# SOUTHERN COLORADO RAIL PARK

### SKETCH PLAN

# V1\_Sketch Plan comments.pdf Markup Summary

Figure 3. 9 Industrial Commercial Collector Typical Section

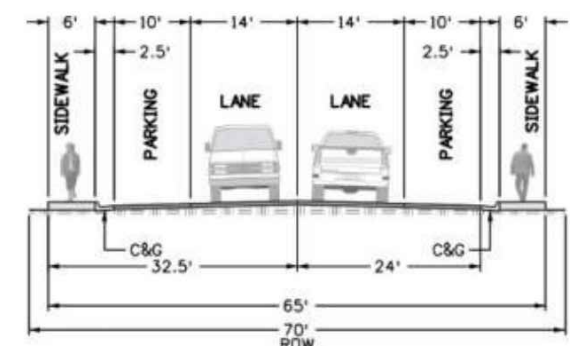
EL PASO COUNTY 2040 MAJOR TRANSPORTATION CORRIDOR PLAN ROAD CLASSIFICATIONS:  
80' ROW PROPOSED 2 LANE COLLECTOR

State City of Fountain standards  
Figure 3. 4 Minor Arterial Typical Section

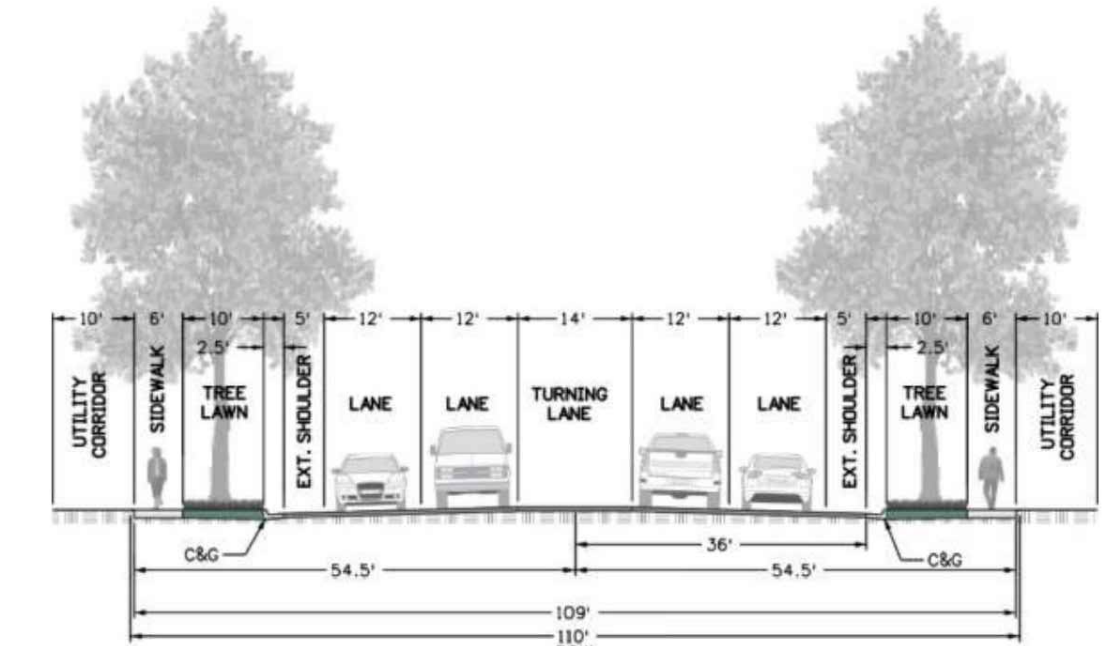
State City of Fountain standards

### SKETCH PLAN

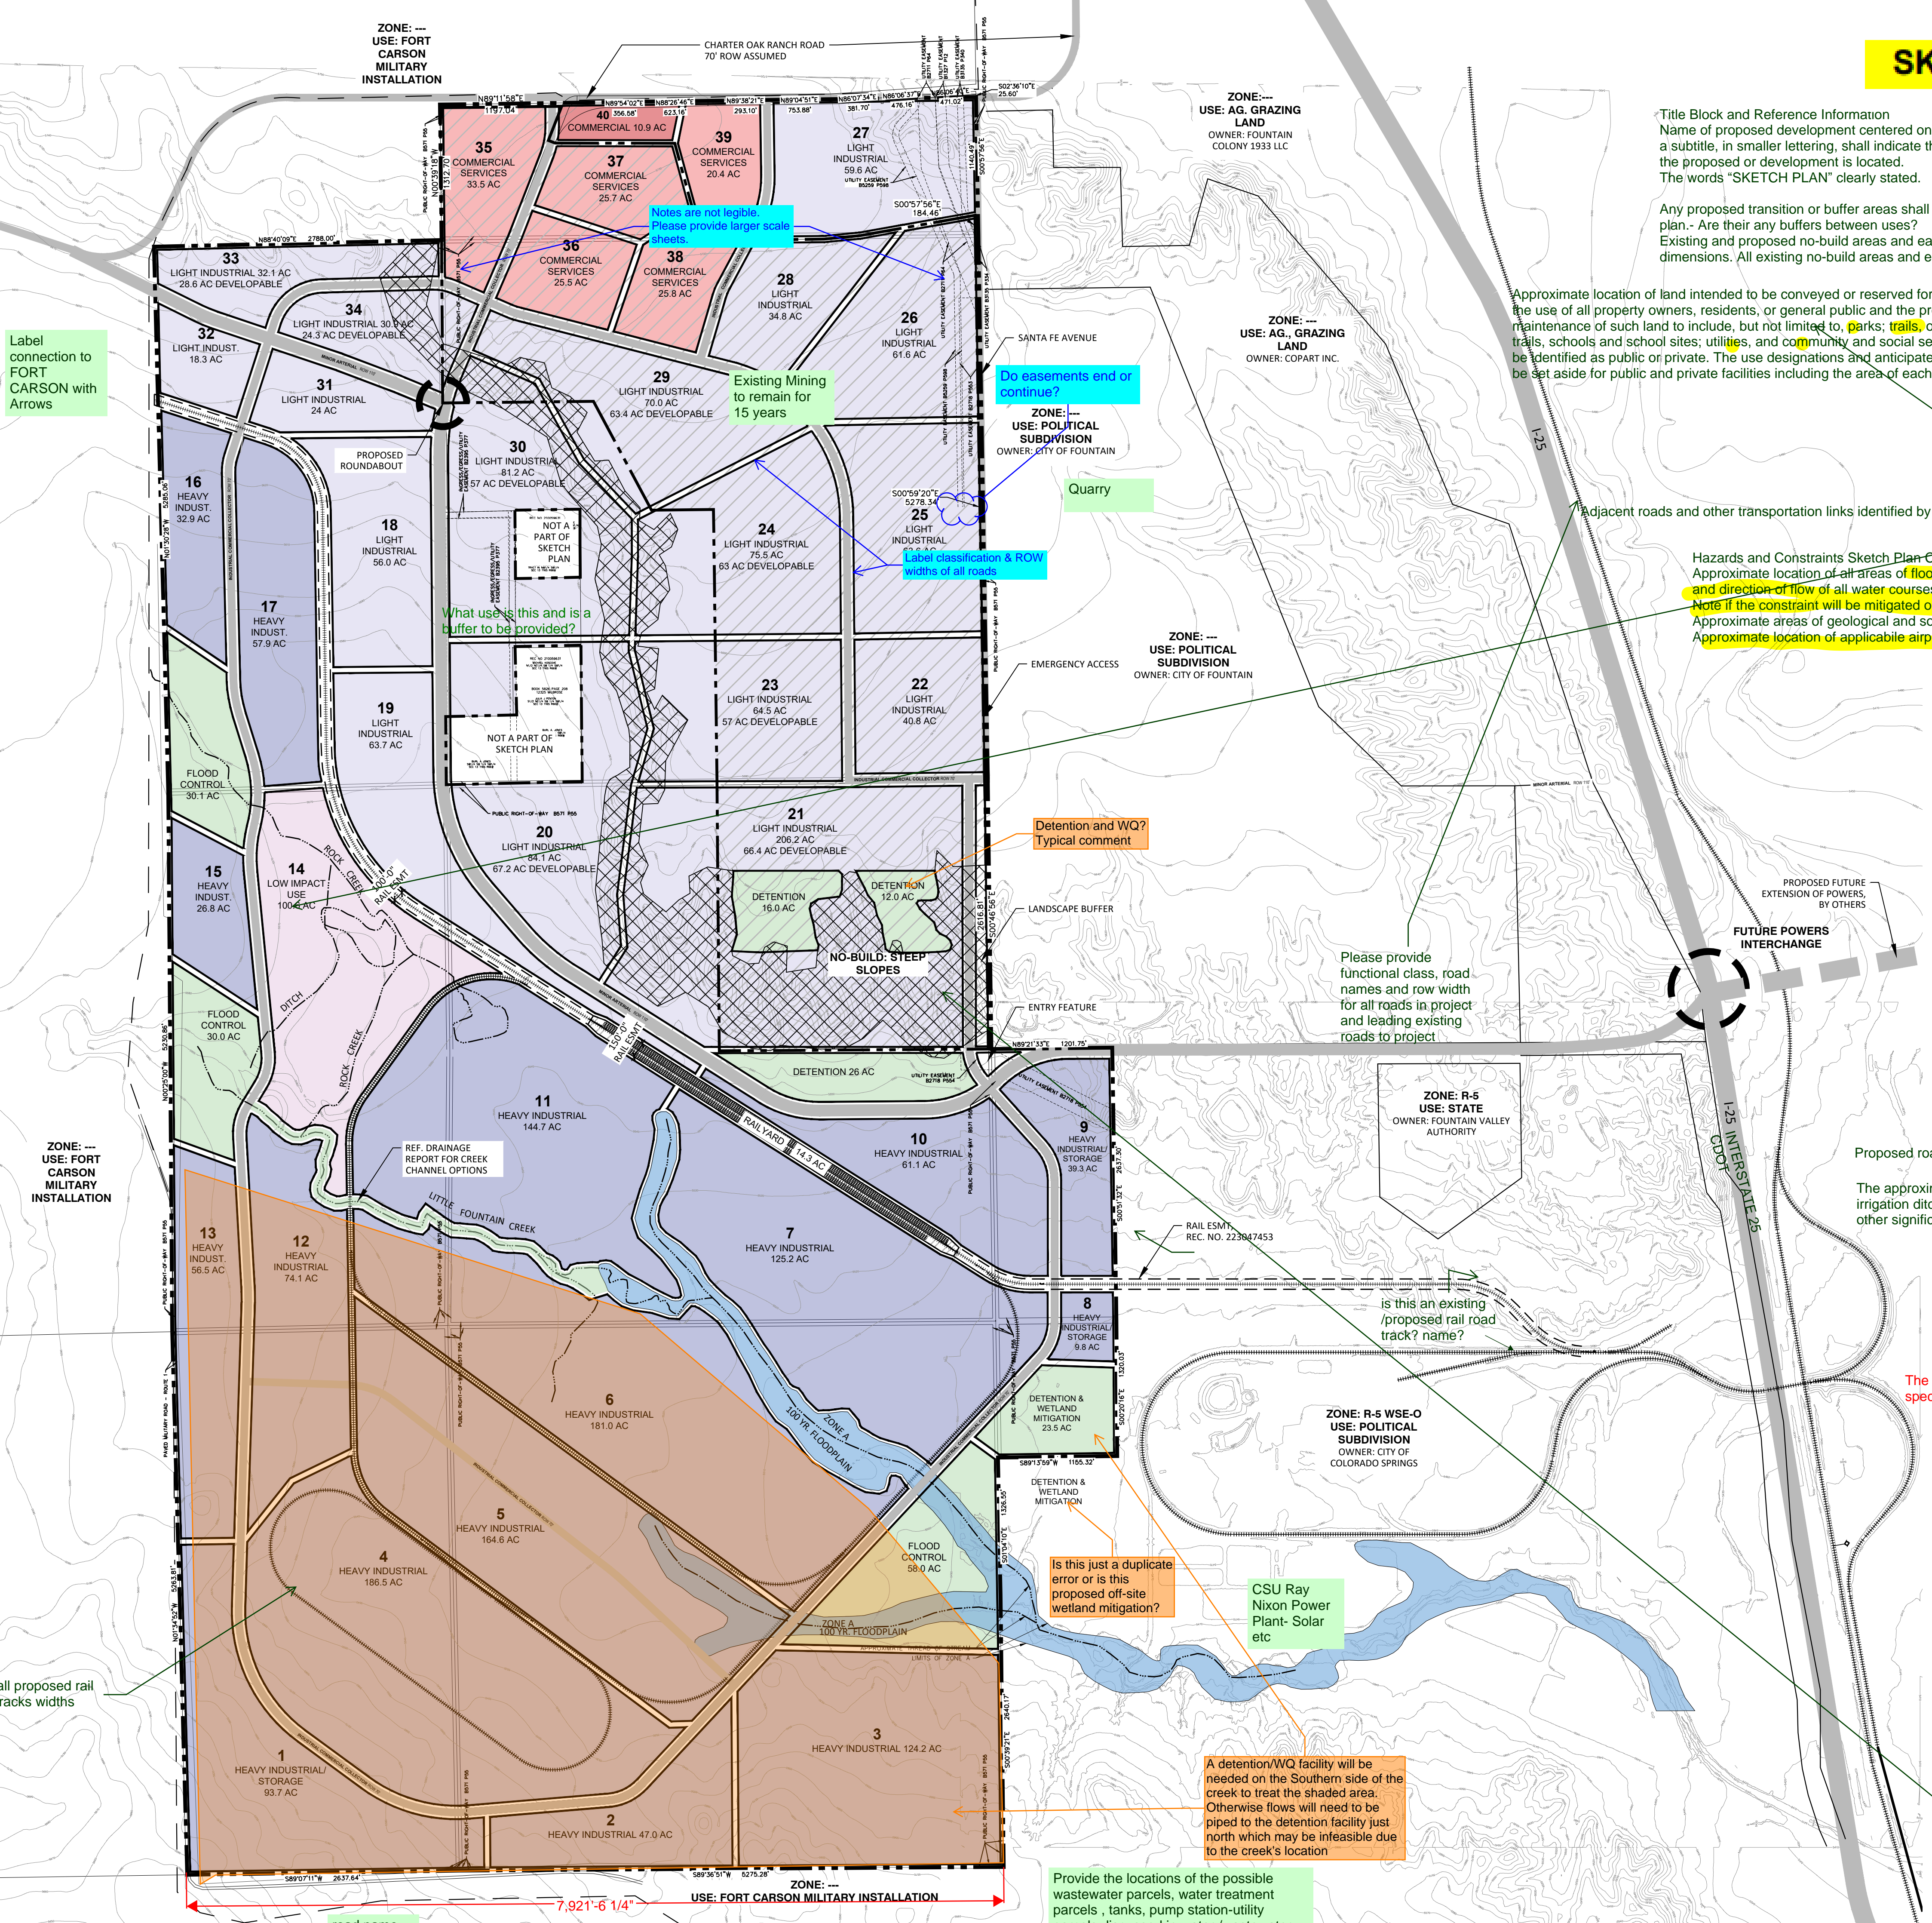
please break into sheets using matchlines 3000+ acres is not legible on one sheet

what is the difference here? Commercial Service is a zone district in the County...

If its preservation open space it cant be developed - is this residential? commercial? park?

A portion is within the CAD-0 Please identify

are there any parks, designated open spaces, or trails for all these employees to use?

where is the debris filed?

Please verify that you have depicted any overhead Power lines or major extensions

Please verify that you have depicted the paleo and archaeological interests on site. Where is the gravel pit on the plan?

Label connection to FORT CARSON with Arrows

Notes are not legible Please provide larger scale sheets.

Do easements end or continue?

What use is this and is a buffer to be provided?

Label classification & ROW widths of all roads

Detention and WQ? Typical comment

Please provide functional class, road names and row width for all roads in project and leading existing roads to project

is this an existing /proposed rail road track? name?

Is this just a duplicate error or is this proposed off-site wetland mitigation?

A detention/WQ facility will be needed on the Southern side of the creek to treat the shaded area. Otherwise flows will need to be piped to the detention facility just north which may be infeasible due to the creek's location

Provide the locations of the possible wastewater parcels, water treatment parcels , tanks, pump station-utility parcels discussed in water /wastewater reports etc

**PHASING PLAN**

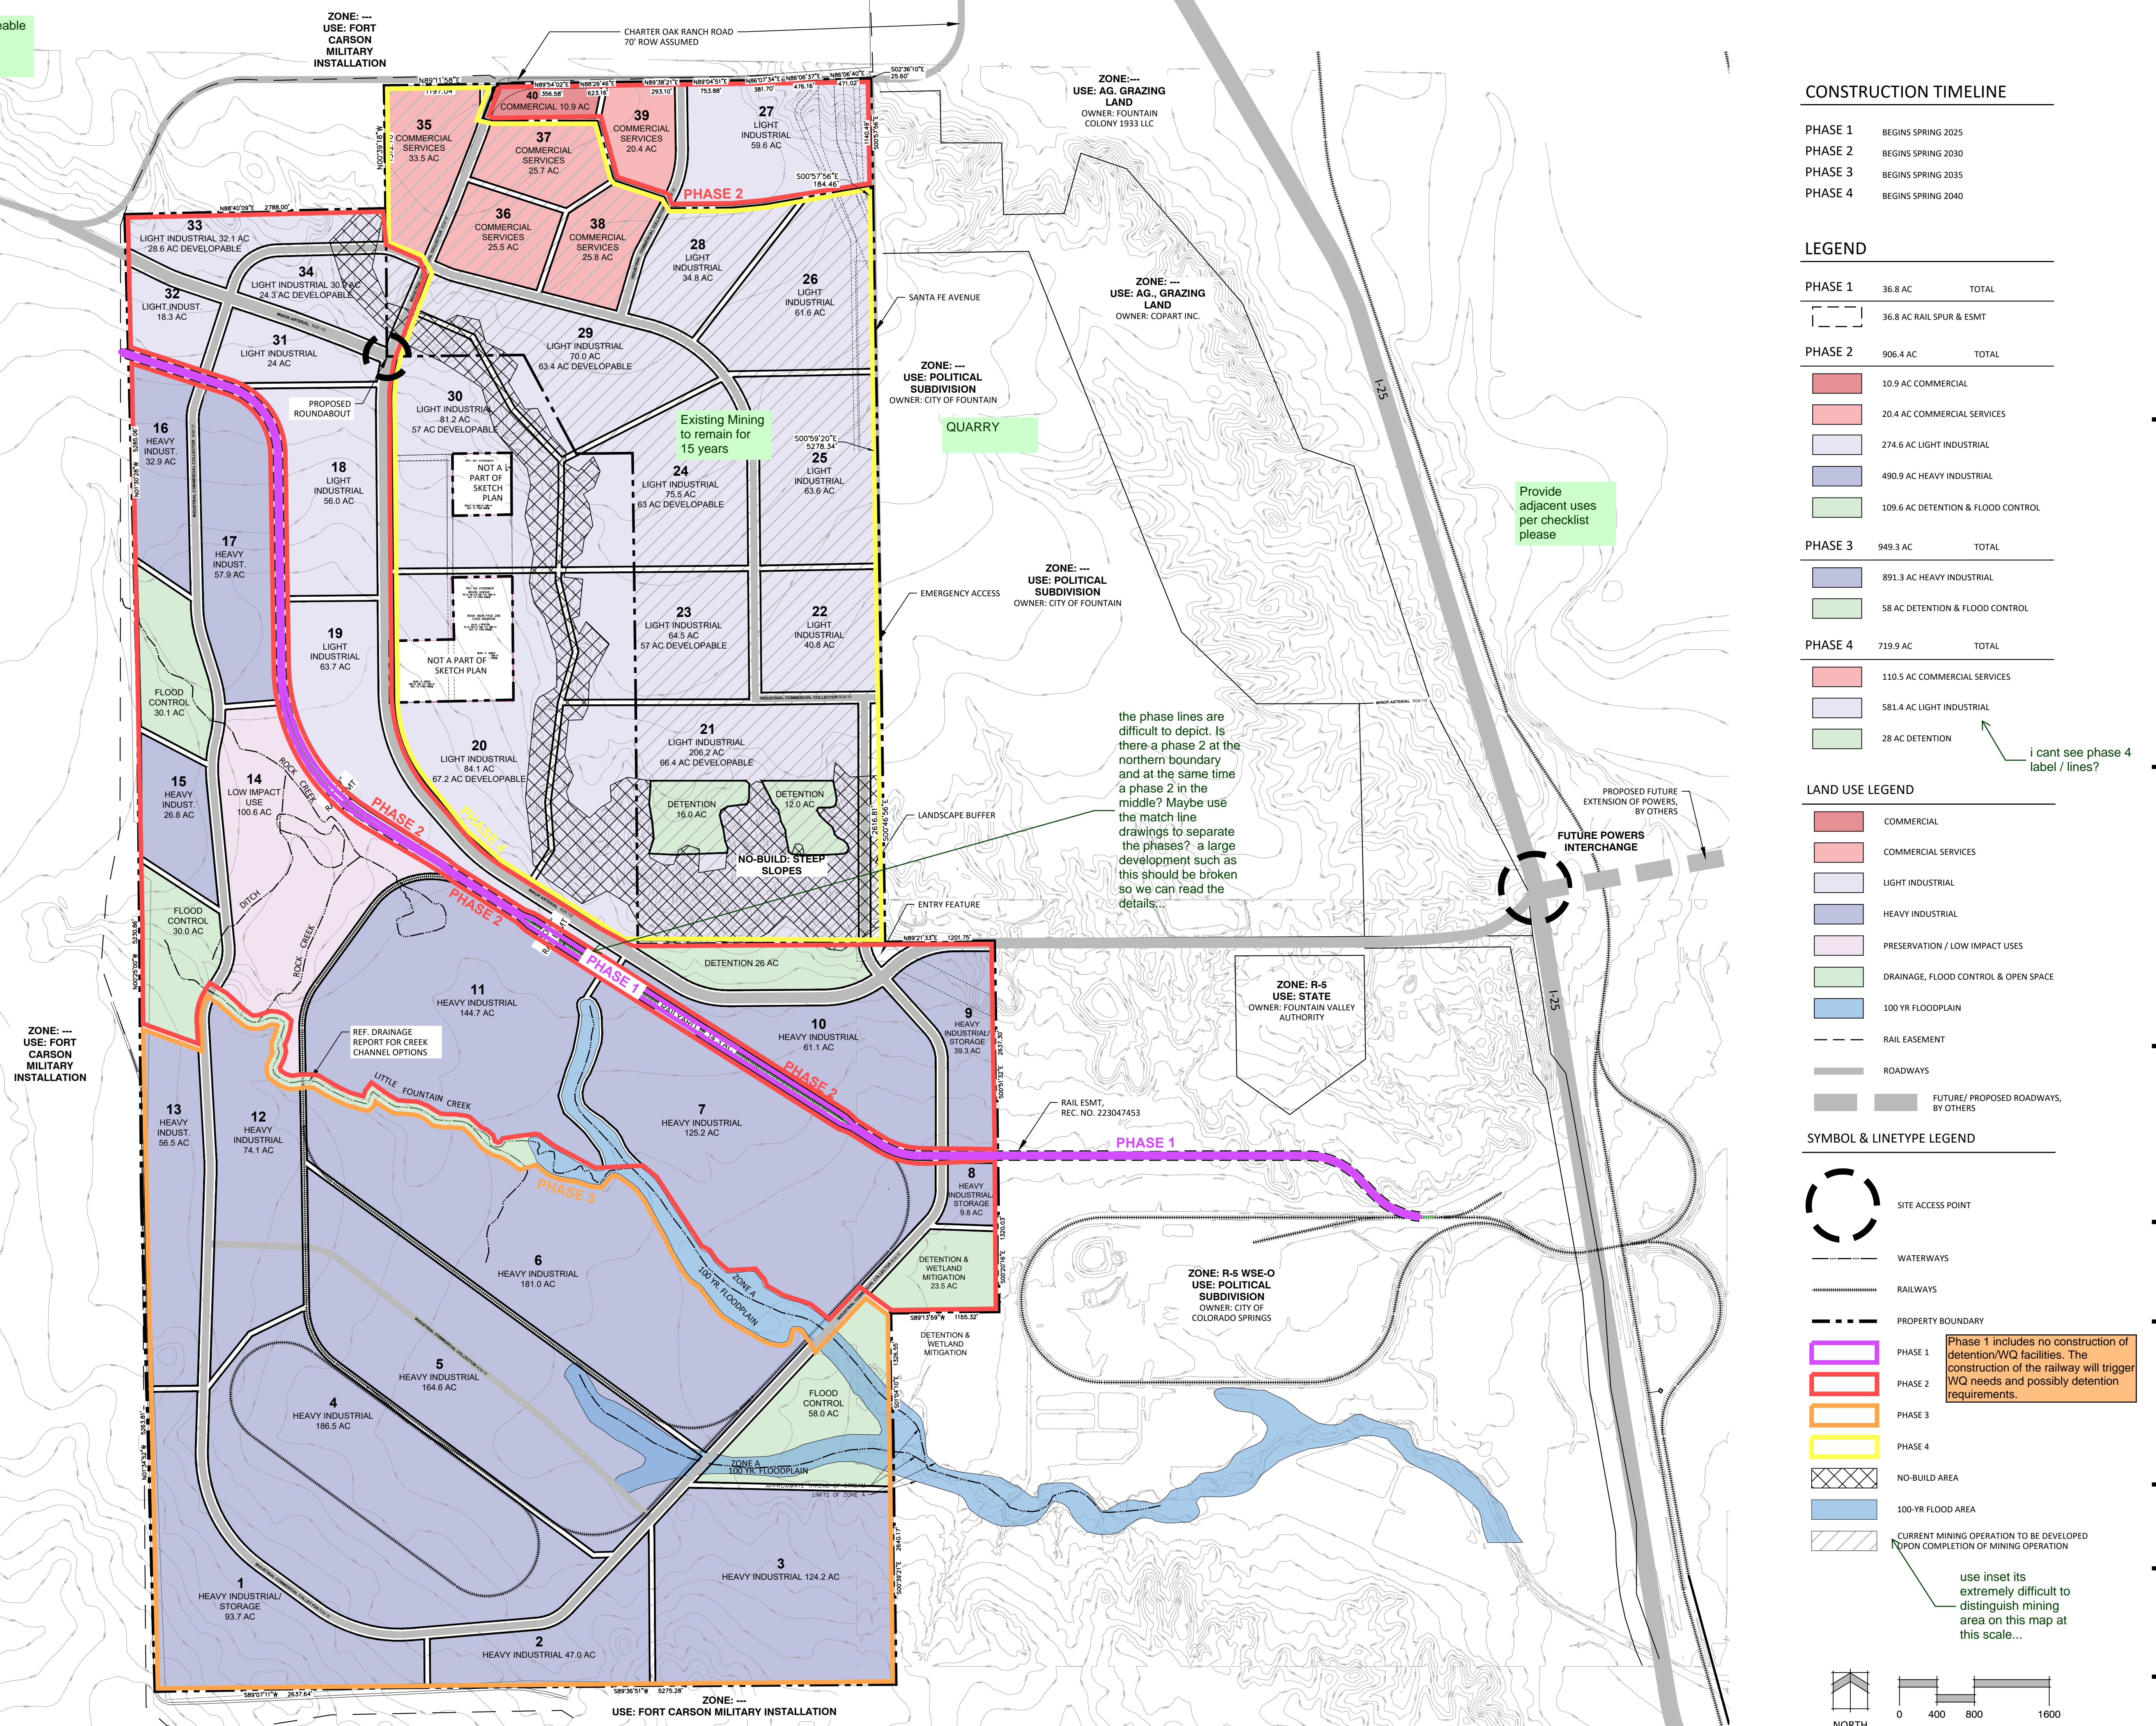
sheet 2 & 3 comments are interchangeable

Phase 1 includes no construction of detention/WQ facilities. The construction of the railway will trigger WQ needs and possibly detention requirements.

use inset its extremely difficult to distinguish mining area on this map at this scale...

the phase lines are difficult to depict. Is there a phase 2 at the northern boundary and at the same time a phase 2 in the middle? Maybe use the match line drawings to separate the phases? a large development such as this should be broken so we can read the details...

i cant see phase 4 label / lines?

Provide adjacent uses per checklist please
